FIRE SAFETY INSPECTION REPORT

Square Apparels Limited

Date: 6 June 2022

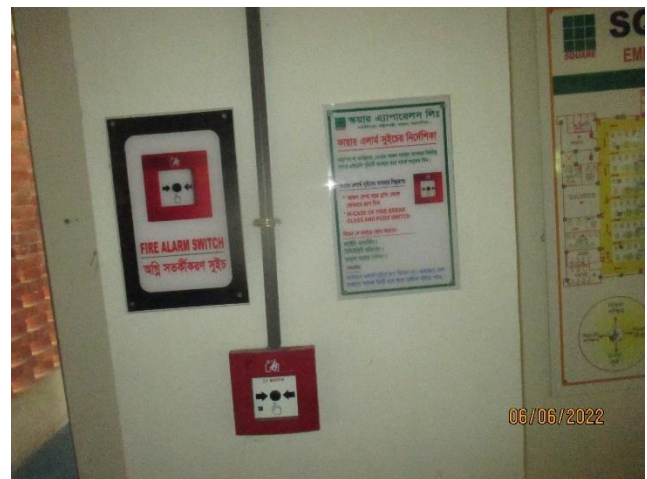
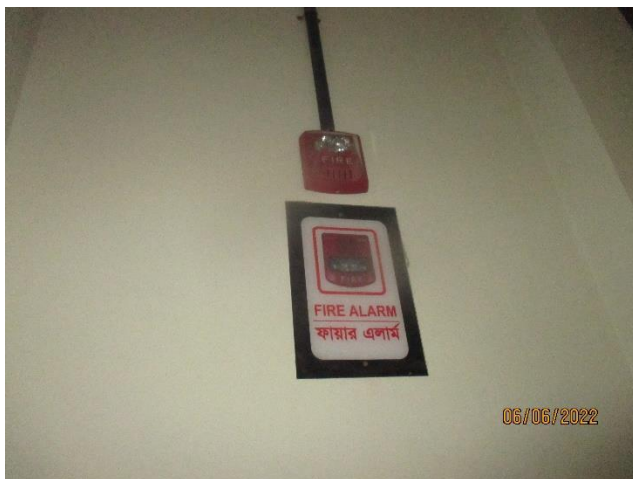
F-2	Egress Lighting	Emergency lighting did not function in test mode (burned out, broken, etc.).	Regularly test the emergency lighting system on each floor and replace/repair lights as needed.	Within 1 month
